Report: TAB REPORT
Function: Test, Adjust, & Balance
Date: 05/31/2023

PROJECT
05-29-23 CULVERS - GRAIN VALLEY, MO

Issue List

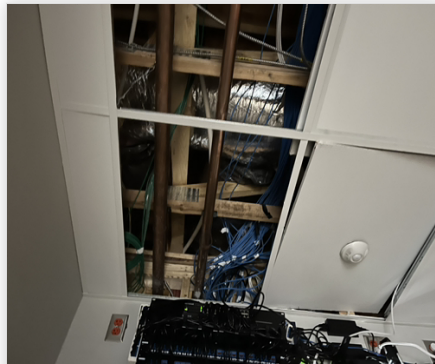
Issue Name : 2. RTU-2 Diffuser 2-16 Low on Airflow, Damper Inaccessible
Description : Diffuser 2-16 on the GRD for the electrical room is very low on flow at 175/600 CFM. Suspect the damper is closed at takeoff. Tech is unable to reach takeoff to check for a damper due to ceiling restrictions.
Created By : National TAB **Assigned To :** National TAB - Jacob Davidson
Status : Open
Originated Date : 05/23/2023 - Jacob Davidson - National TAB
